I. AMENDMENTS TO THE DRAWINGS

FIG. 1

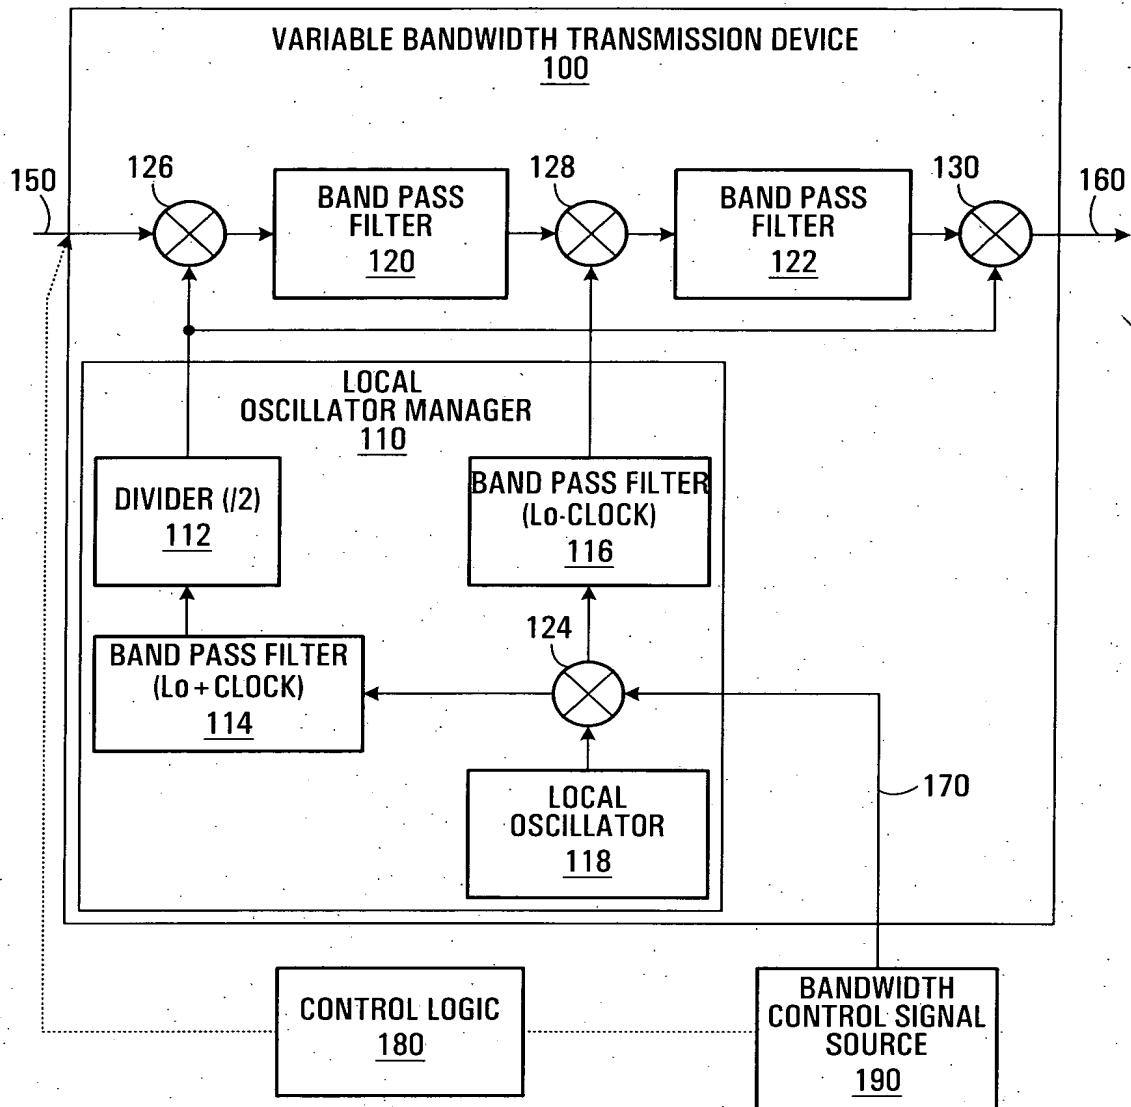
During the course of reviewing the present application, it was noticed that item 100 of Figure 1 was not correctly labeled. Accordingly, item 100 of Figure 1 has been relabeled as "VARIABLE BANDWIDTH TRANSMISSION DEVICE" as specified on page 3, paragraph 6 of the specification as filed. It was also noticed that item 200 of Figure 2 was not correctly labeled. Therefore, item 200 of Figure 2 has been relabeled as "VARIABLE BANDWIDTH RECEPTION DEVICE" as specified on page 10, paragraph 2 of the specification as filed.
